Malmesbury Road, Cricklade

Mac Mic Strategic Land Limited

Technical Note – Response to WC Highways
Initial Comments 21.5.26

June 2026

Figure 2.1 CD123 Exert of Junction Type Guidance

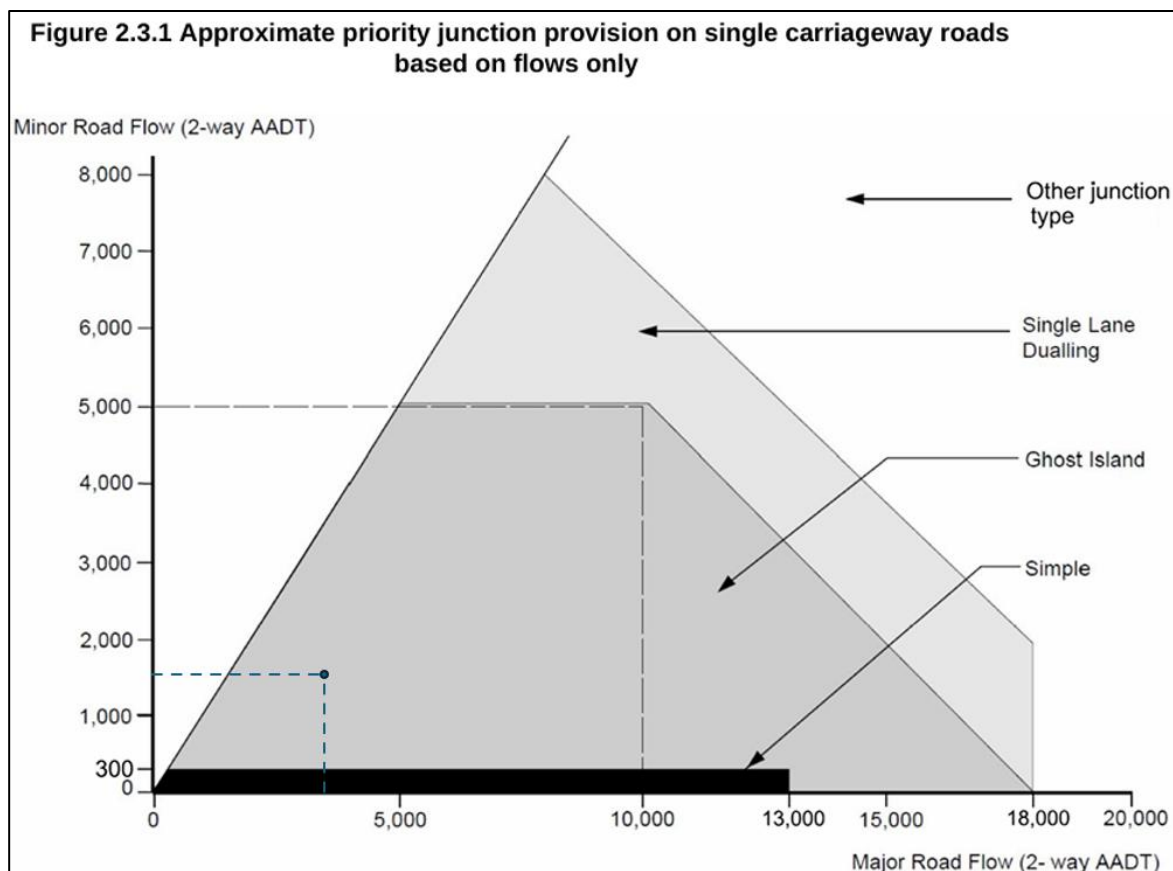
Therefore, to make a detailed highway response to the proposals I wish to be provided with analysis of CD123 and the provision of a RHT lane before accepting the final layout of the access arrangements. This can be in the form of an addendum to the TA.

- 2.9 As demonstrated in **Figure 2.1**, based on flows alone, a simple priority junction would typically be suitable for major road flows up to around 13,000 two-way AADT with minor road flows of around 300 two-way AADT. This is a very low threshold and would suggest that almost any residential development over c. 60 dwellings would need a right-turn lane. This clearly isn't necessary or appropriate in most cases and not how it's applied in practice. which clearly isn't necessary or appropriate in most cases and isn't how it's applied in practice.
- 2.10 Relevant to the proposed development, **Figure 2.1** demonstrates that, based on the flows identified in **Table 2.1**, it *may* be appropriate to provide a Ghost Island Right Turn Lane to access the site rather than a simple priority junction. However, the flows are only slightly

above those recommending a simple priority junction and this is an initial guide which requires case-by-case consideration.

2.11 It should also be noted that DMRB guidance applies to motorways and trunk roads and is not always an appropriate guide for urban, semi-urban or residential streets. In this instance a more appropriate reference point would be Manual for Streets (MfS) / Manual for Streets 2 (MfS2).

2.14 Therefore on this basis, and taking into account the relative low development traffic flows and flows on the main road, a ghost island right turn lane is not considered an essential requirement for the proposed development. Instead, the merits of a ghost island right turn lane, beyond the provision of a simple priority junction, should be considered further to determine whether a ghost island right turn lane would be appropriate or not in this location, for this scale of development.

Figure 2.2 Key Active Travel Routes

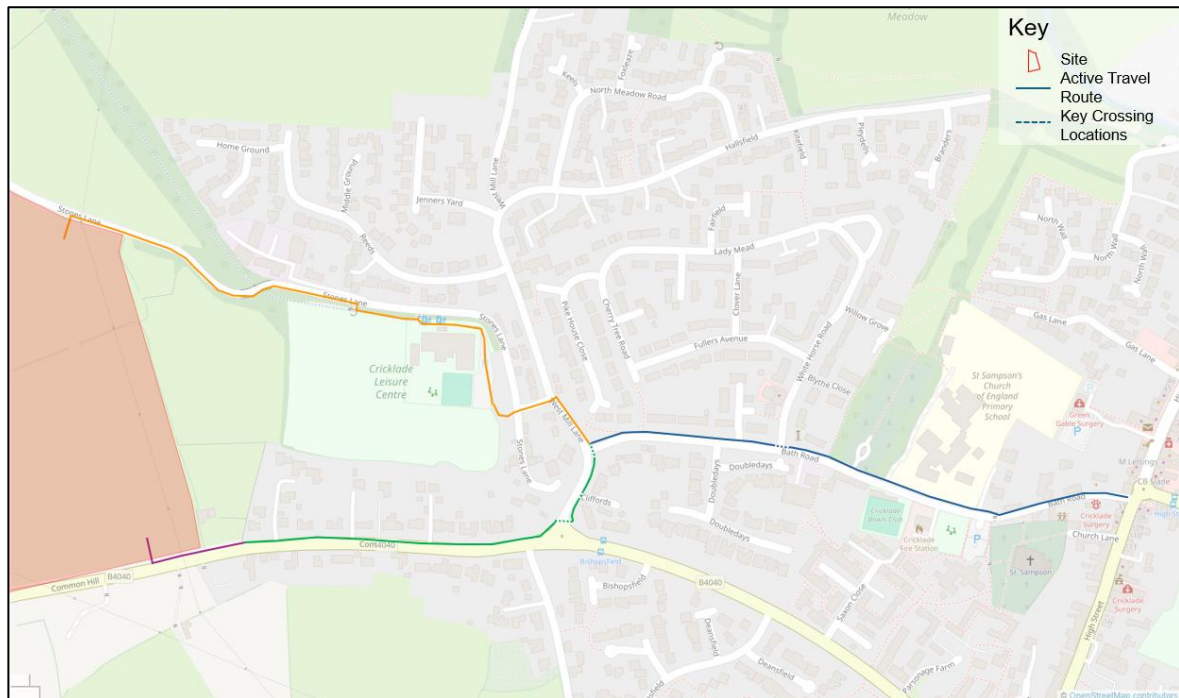
- 2.30 The second issue raised by WC, is a perceived lack of connectivity between the site and the town centre. WC acknowledge that the site is sustainable given the availability of a range of facilities within walking distance, which includes Cricklade town centre. However, WC assert there is a lack of “*desirable link*” between the site and Cricklade town centre.
- 2.31 This view is disputed. Future residents will have two principal route choices available, which offer attractive, user friendly, desirable routes to/from the town centre. These routes are shown on **Figure 2.2**, and discussed below.

- 2.32 The first route, routes along Malmesbury Road. As part of the proposals (or in combination with the adjacent Bloor application) a new 2.0m footway is to be delivered, this is delineated in purple on **Figure 2.2**. This will ensure that residents exiting the site from the southern frontage onto Malmesbury Road will be able to access a lit, 2.0m footway which routes east towards Cricklade.

- 2.33 East of Horsey Down this route continues along Common Hill along the existing infrastructure, shown in green on **Figure 2.2**. At the junction with Common Hill and West Mill Lane, pedestrians will route along West Mill Lane before continuing along Bath Road to route east towards the town centre (shown in blue). This route is already well utilised by existing residents and delivers continuous street-lit footway provision and is supported by uncontrolled pedestrian crossing points.

- 2.37 The second key route from the site towards town is along Stones Lane, shown in orange on **Figure 2.2**. It is noted that this utilises Stones Lane which has no dedicated infrastructure however it is a low speed, low-traffic volume environment, which characteristics align with the “quiet lane” principles endorsed by LTN 1/20 and MfS. It is therefore considered appropriate for use as an active travel route.
- 2.38 Furthermore, in the event that the neighbouring site is able to secure a connection onto the Cricklade Railway route, then the site is well positioned to provide a connection through the Bloor site onto the disused railway and provide an additional, alternative route to Stones Lane. Whilst this additional route is dependent on third-party land, the applicant has demonstrated a commitment to safeguard a potential connection within the site layout as appropriate.

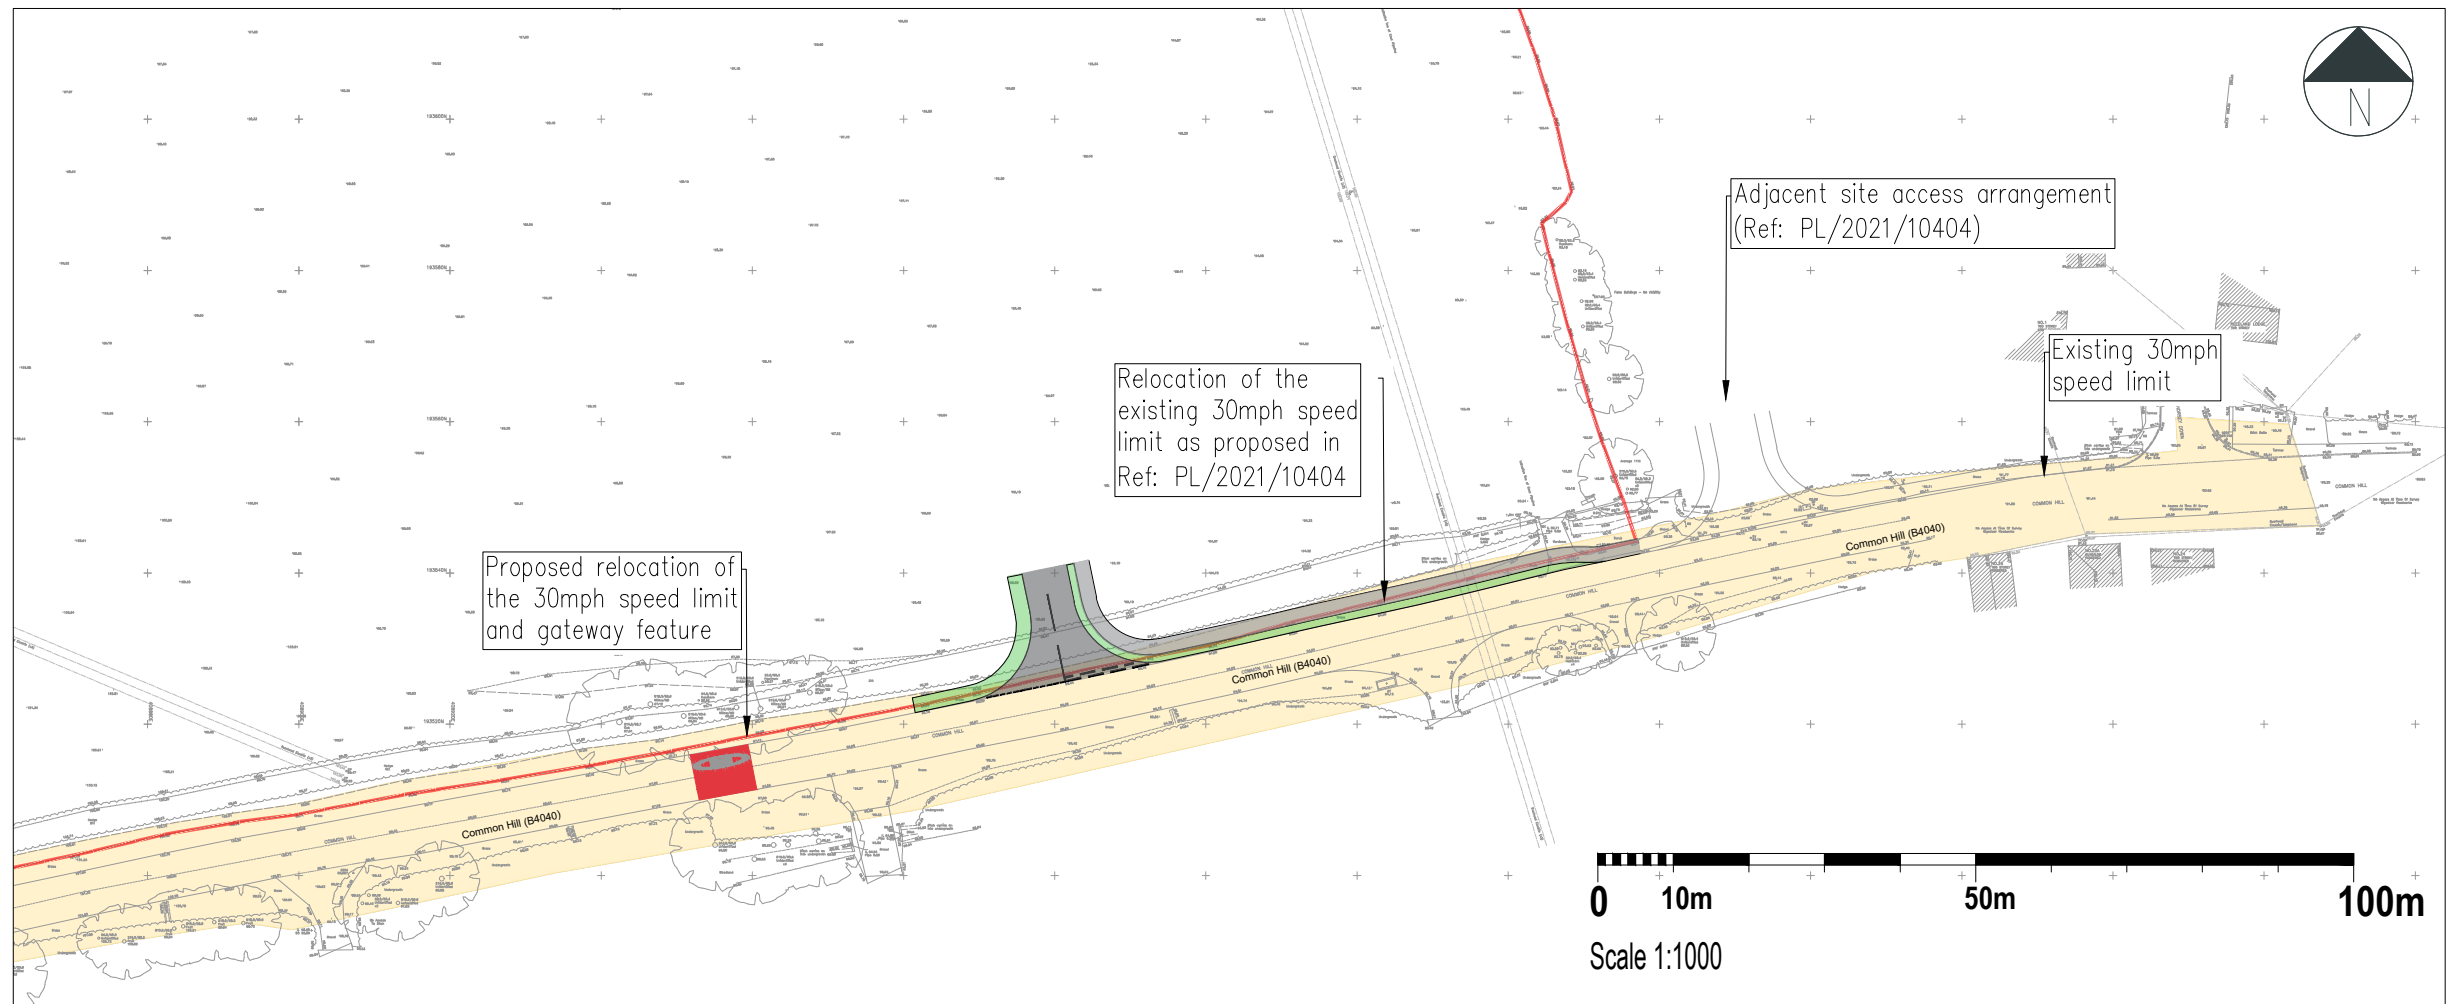
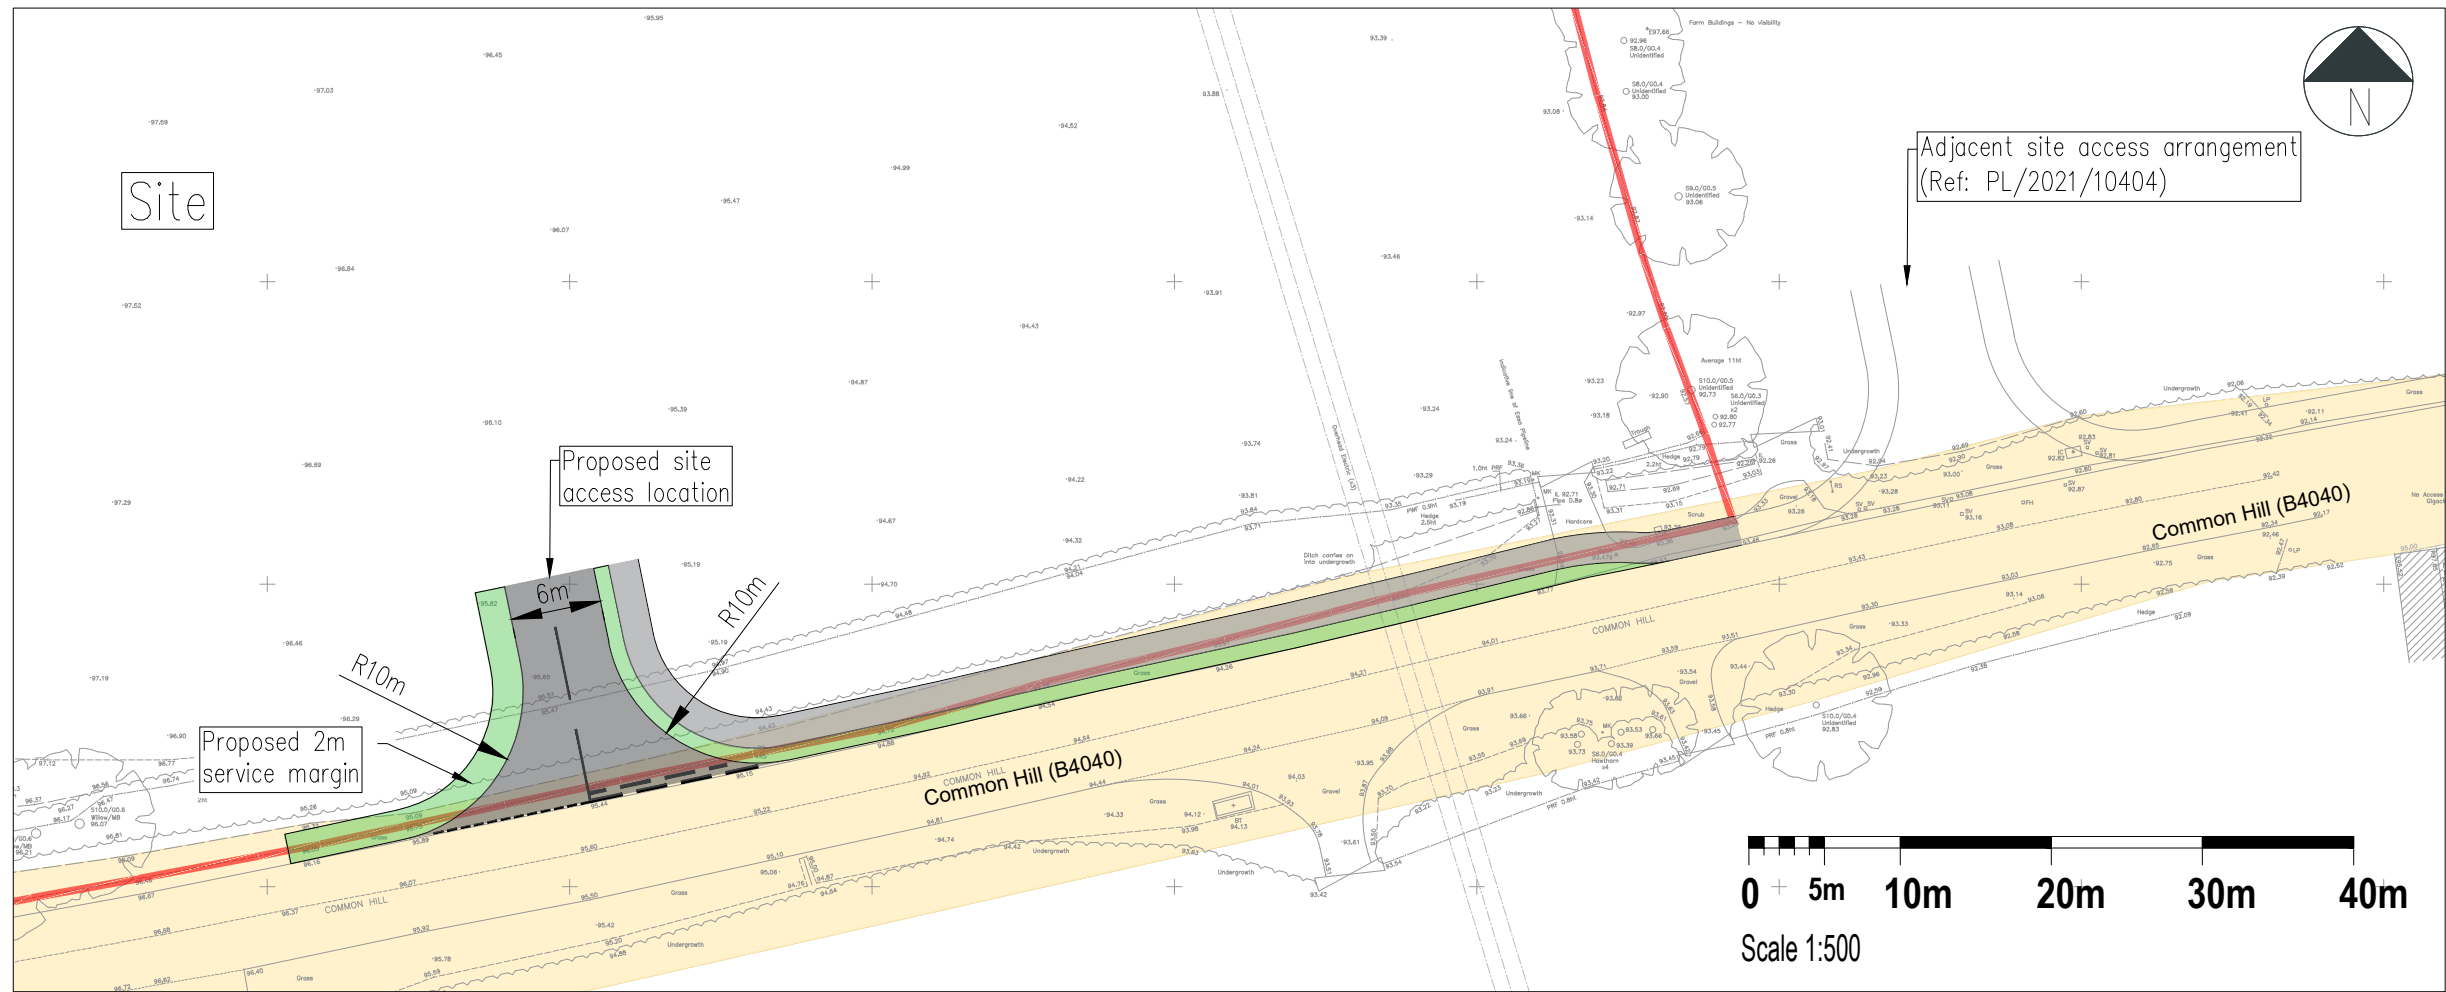
Given the access design must be agreed at the outline stage I require additional certainty that the design parameters proposed best fit the design purpose and safety requirements prior to signing off this arrangement.

I note the Transport Assessment provided concludes that a simple priority junction is suitable and I am satisfied that the trip analyses and modelling has been applied in an appropriate manner indicating small values in wait time while accessing the junction on the B4040 Common Hill and the proposed access to the development. However, no justification has been offered within the TA or the RSA referenced against the inclusion of a right turn lane. While DMRB is referenced in general terms, the proposals have not been scrutinised against guidance contained within CD123 revision 2.
